Agenda Item 3
710 Green Briar Lane
Revisions to Previously Approved Plans

Consideration of a request for revisions to previously approved plans for a new residence on a vacant lot.

The property owner now wishes to proceed with development of the property, with a modified plan. The owner submitted modified plans for permit and after review, staff determined that the changes made were significant enough to require further Board review. The reason for the modified plan based on information from the petitioner, is to reduce the amount of second floor living space and by doing so, reduce the cost of construction. The project is now moving forward, with a new architect and civil engineer. The architect who originally designed the house is no longer involved with the project. The request now before the Board seeks approval of changes including changes to the footprint of the residence, the overall massing and roof forms.

Review of Proposed Changes and Comparison to the Previously Approved Plan

EAST SIDE ELEVATION

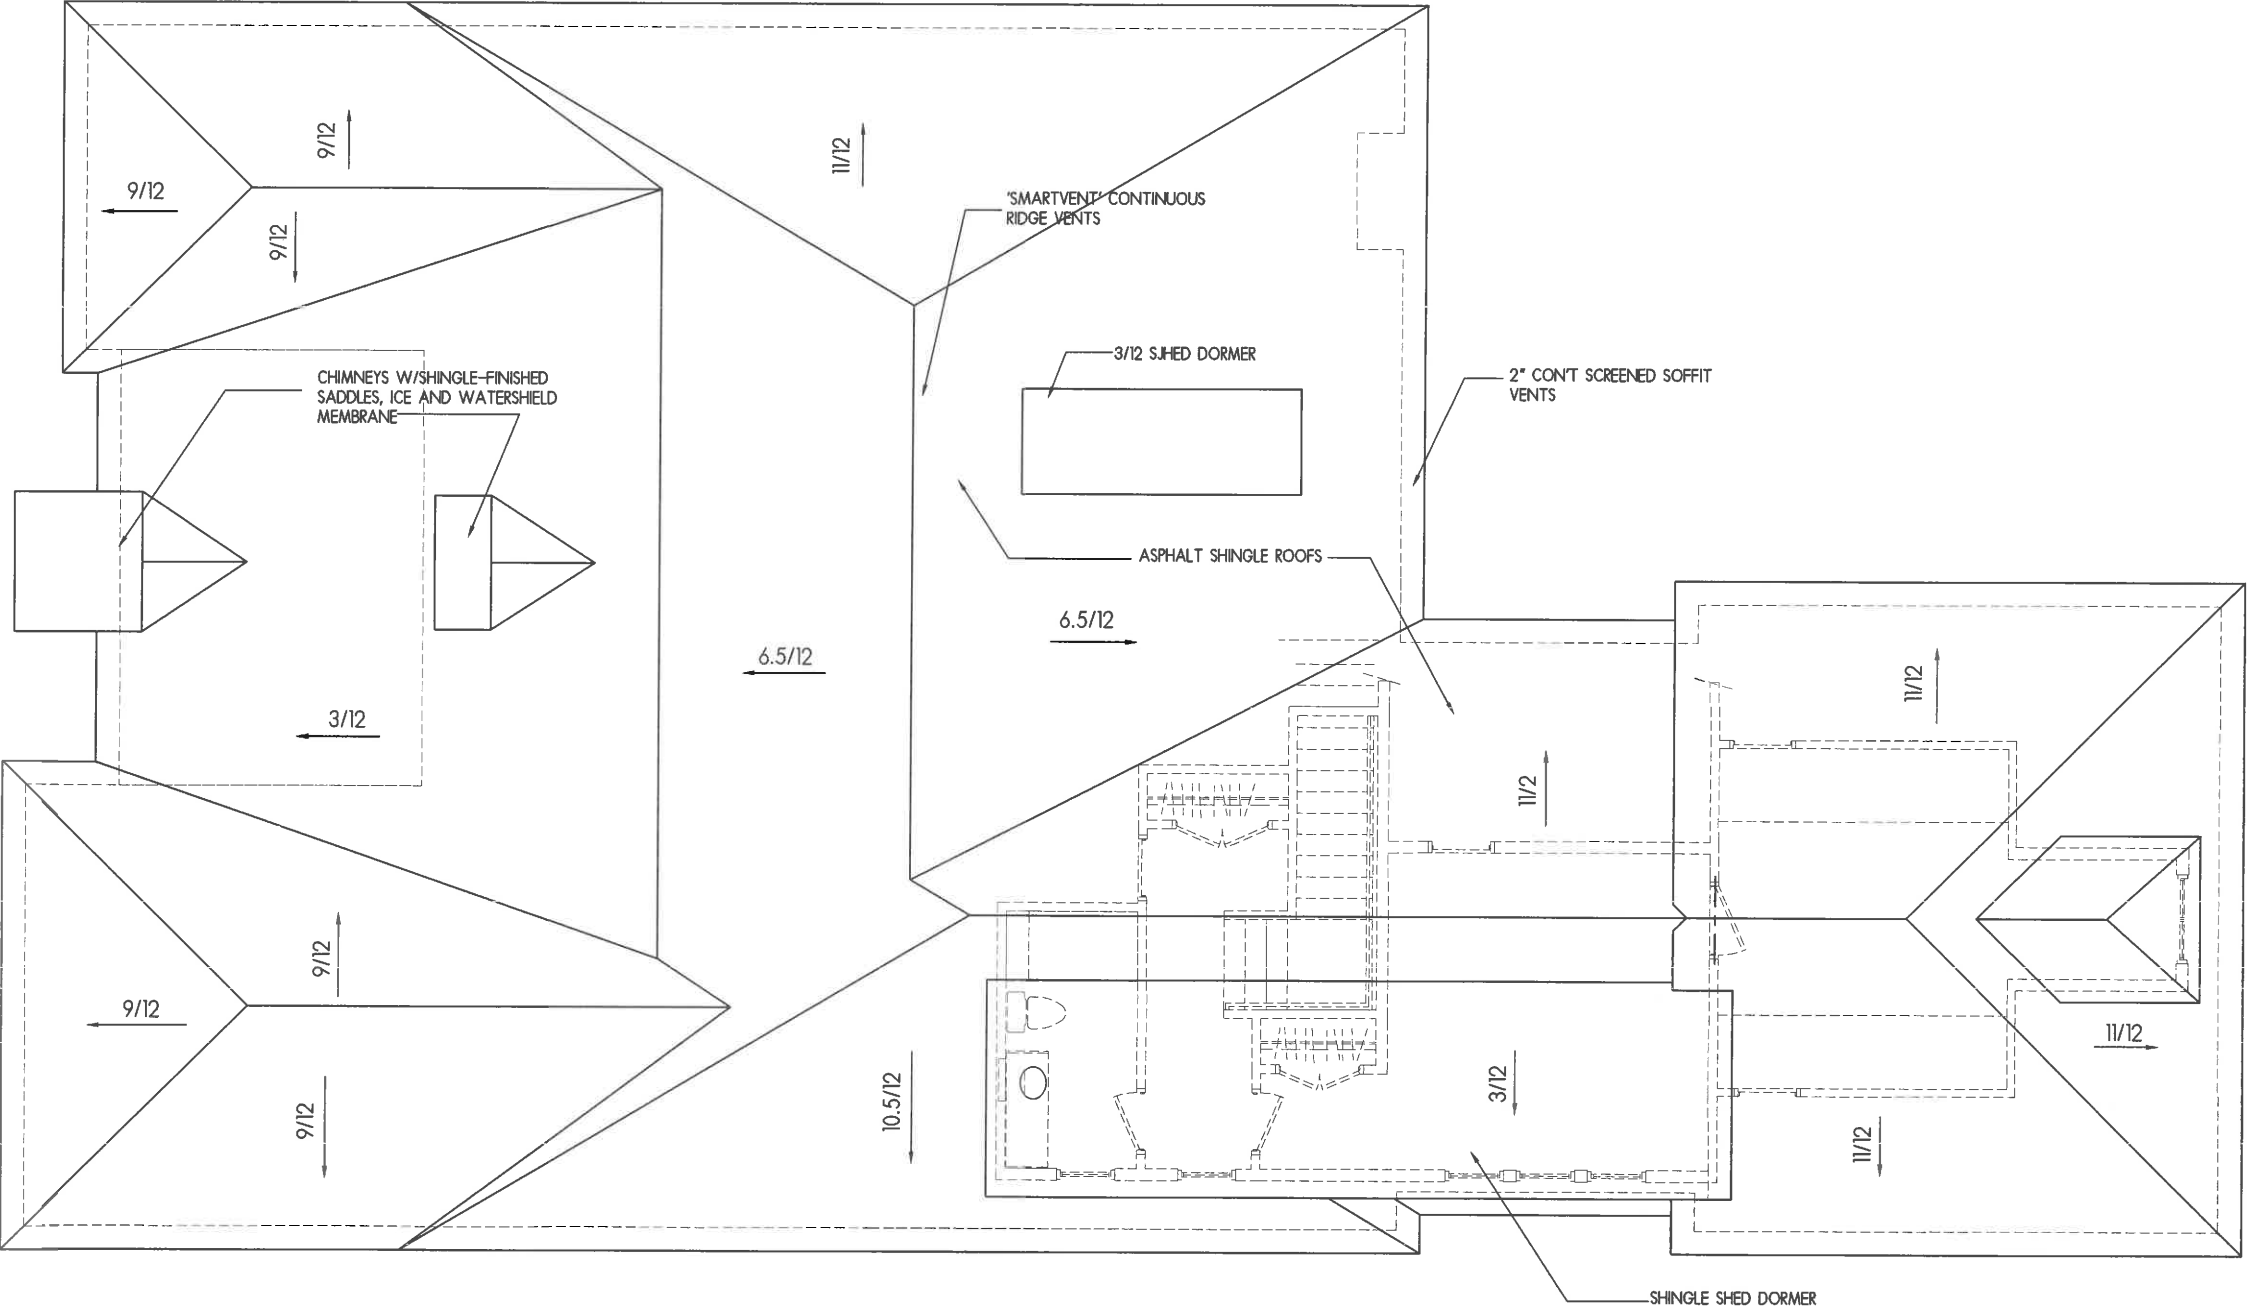
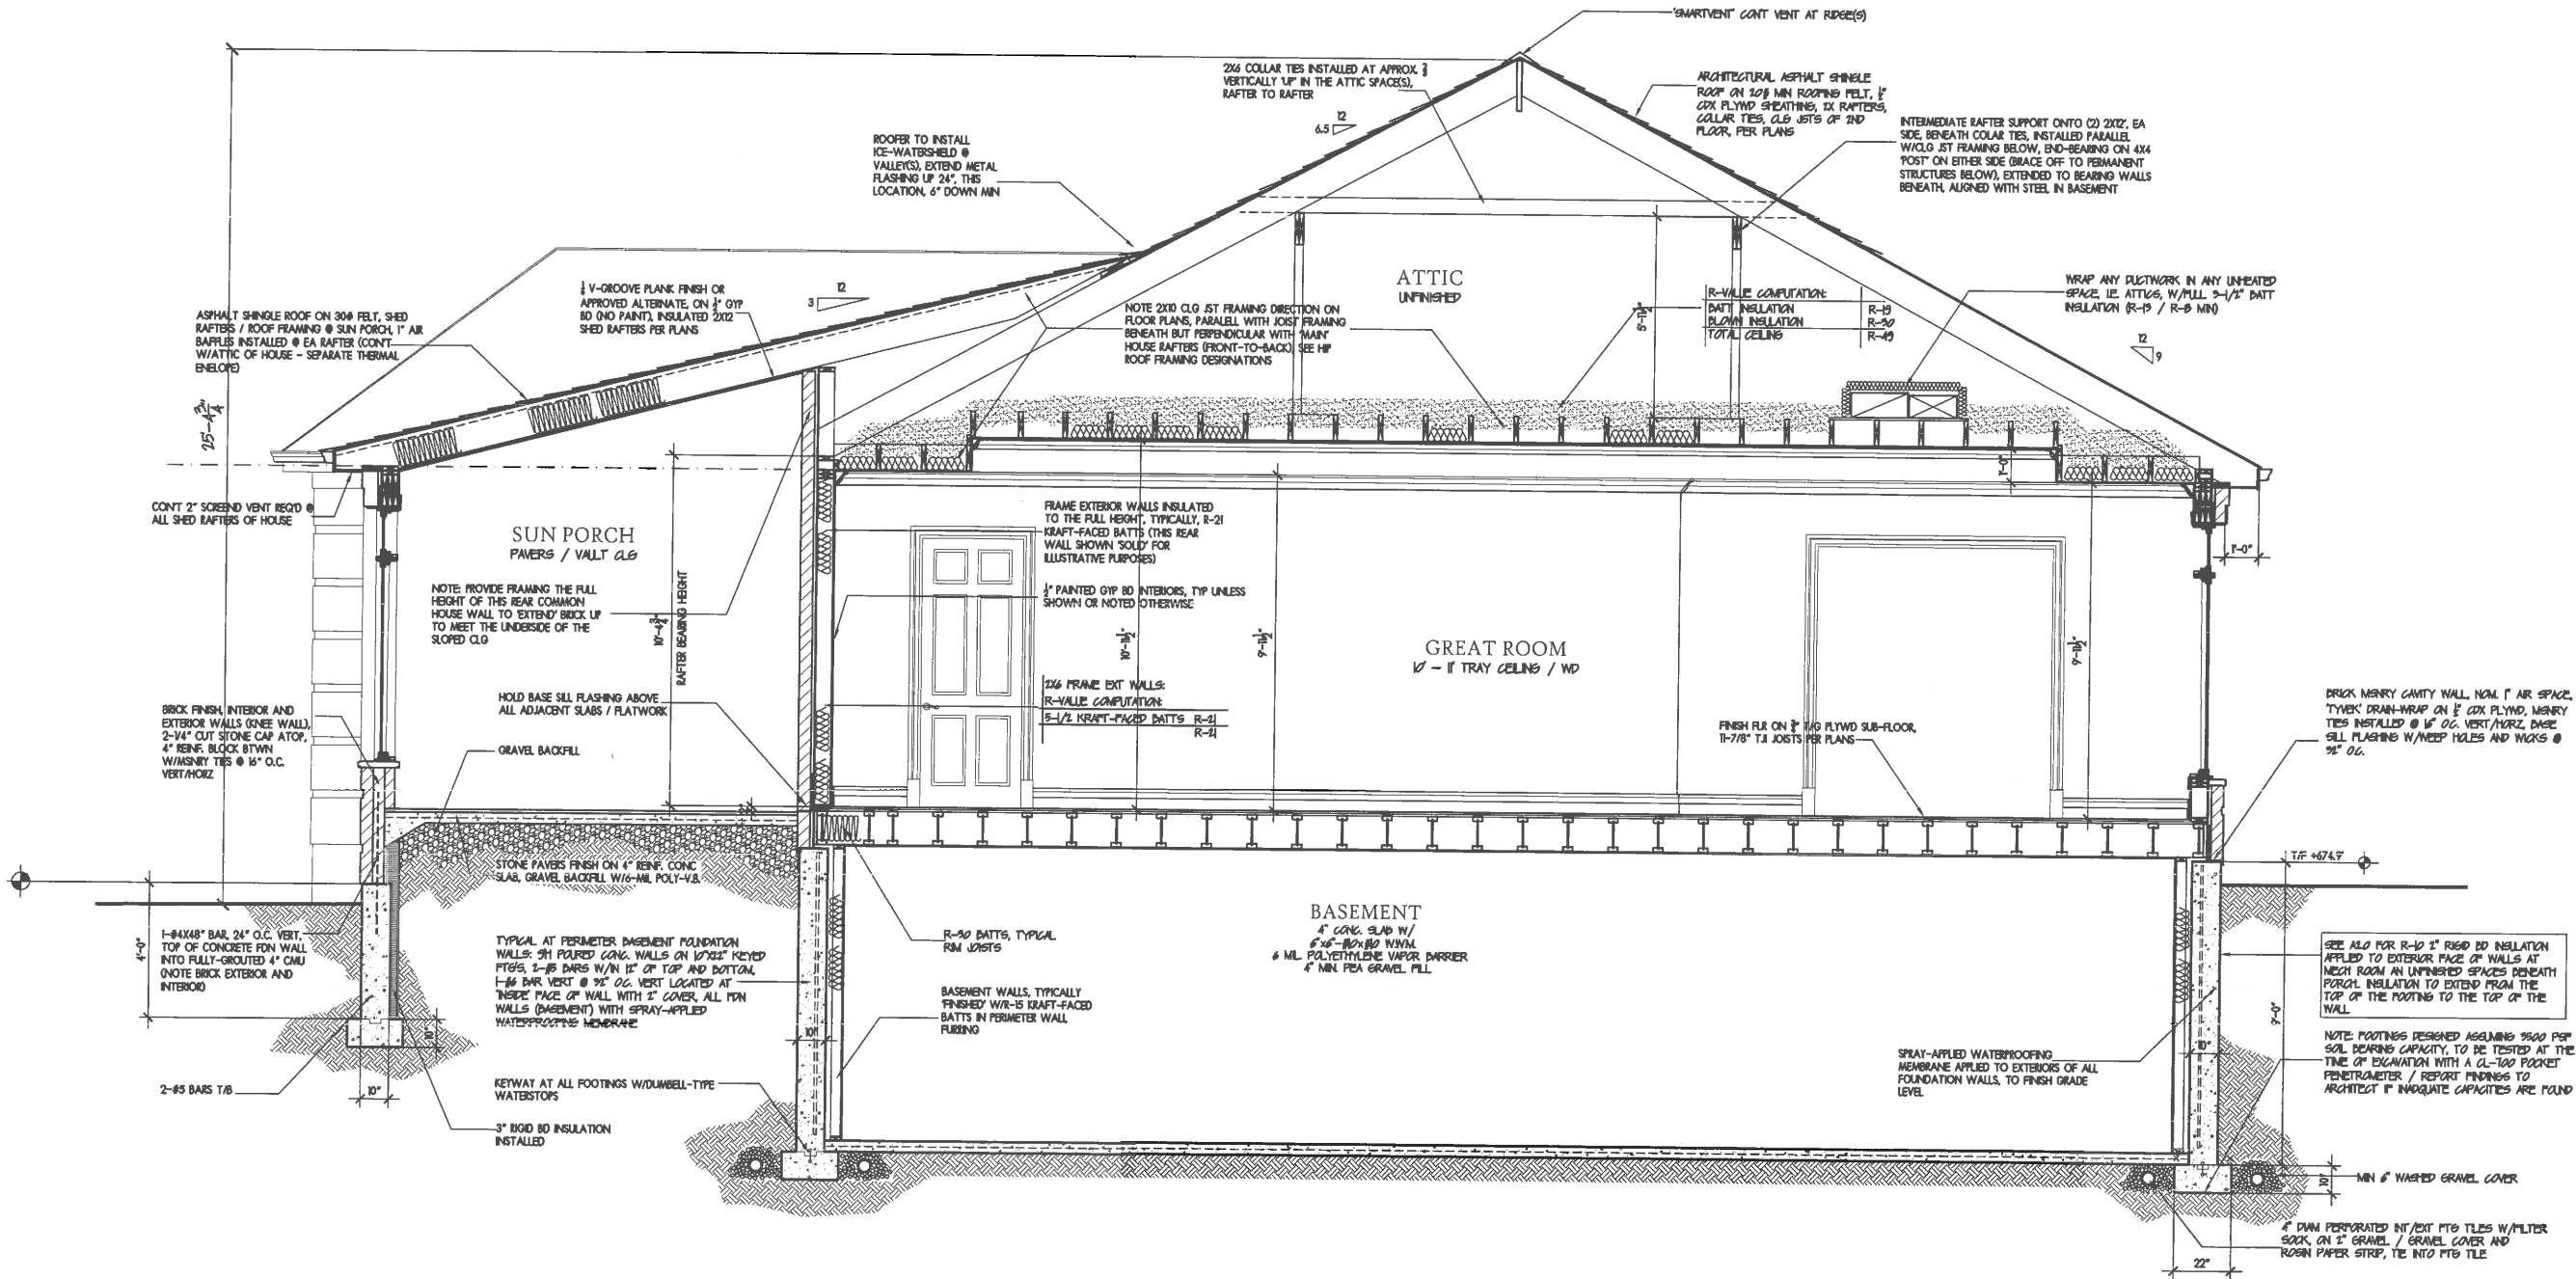
- Hip roof forms are now proposed to replace the previously proposed gable roof forms.
 - As currently proposed, the hip roof above the main mass of the home presents a very large and stretched out appearance. Board input on the hip roof above the main mass of the house is requested.
- The window placement and proportions were modified.
 - Consideration should be given to the placement of the windows in a more regular pattern.

- Overall, the depth of the home (north-to-south length) has been shortened considerably, by almost 12 feet
- Garage doors of 3-car garage, scale 'increased' to for an improved proportion of materials – brick to garage door (above the doors specifically)

- Front (south) exposed roof planes – now designed as 'hip roofs' – the garage with an 11/12 pitch, the main house with a 6.5/12 pitch; the hip roofs intent is to soften the compositions and de-mass the structure (less imposing)
